ADDENDUM NO. 2
FOR
STREET REHABILITATION
(RECLAMATION, RESURFACING AND DRAINAGE)
CDBG PROJECT NO. SM-CM-PF-16-010
FOR
THE TOWN OF COLLINSVILLE

JUNE 14, 2017

SUBJECT: Plans, Specifications, and Contract Documents are hereby amended, modified, and changed as follows:

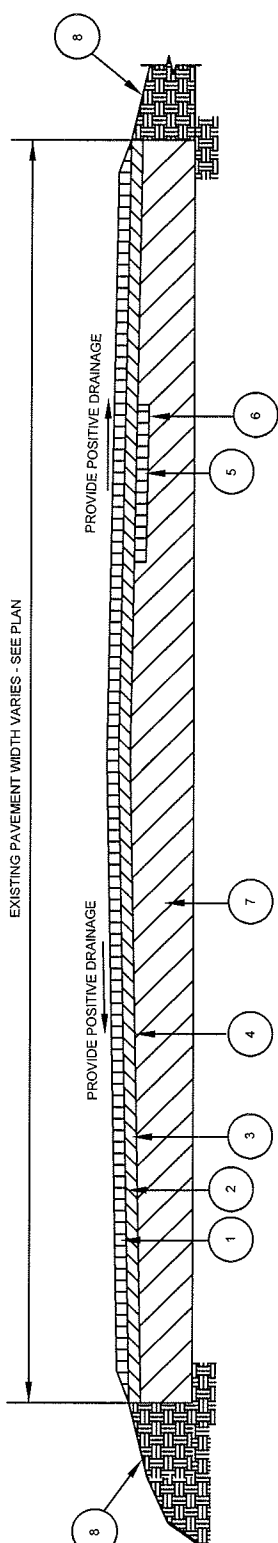
- D. Replace Detail "A" with the attached Detail "A" on page ADM2-11
- E. Replace Detail "B" with the attached Detail "B" on page ADM2-12
- F. Sheet 4 is hereby added to the plans. Add Detail "A," Sheet 4 on the attached Page ADM2-13.

ADM2-13

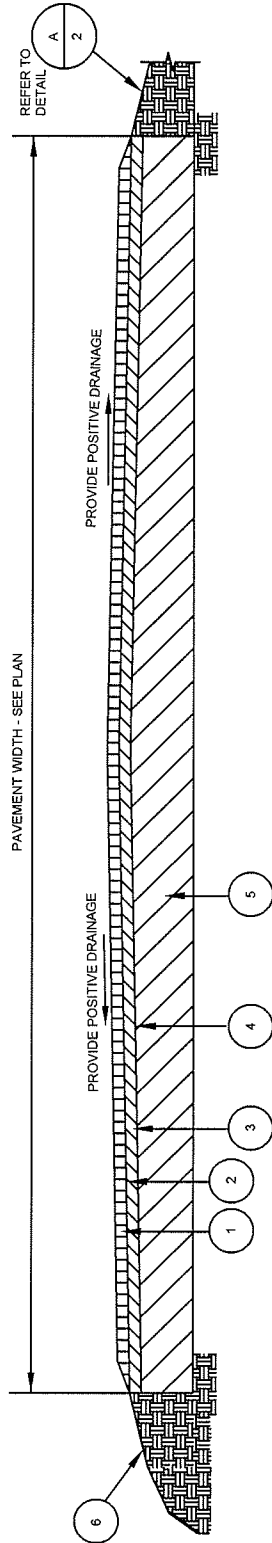
- B. On Sheet 2, Detail "A," change the Detail reference on Note 2 from Detail "B," Sheet 2, to Detail "A," Sheet 4.
- C. On Sheet 2, where noted to install rip-rap, Contractor shall install permeable separator geotextile beneath Class 1 rip-rap. Rip-rap shall cover area as wide as ditch and to the top of the bank.
